Infonote

AO-IN-2023-048-I

Enlarge the DMC marking dot size
for KY CELNM2.FY device

01.12.2023

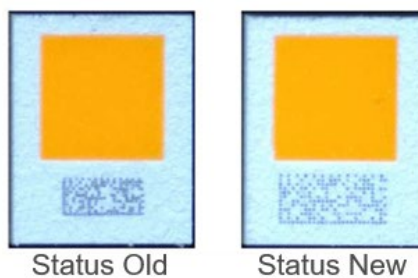
Objective: Enlarge the DMC marking dot size for KY CELNM2.FY

Reason for change:

- 1) Standardization on the DMC size for same package size
- 2) Better readability, inhouse and in case of customer returns

Description of change:

Size of dot, μm	Num dot	Dimension, μm
Status Old	25	X: 26 , Y:12	X: 650, Y: 300
Status New	35	X: 26 , Y:12	X: 910, Y:420
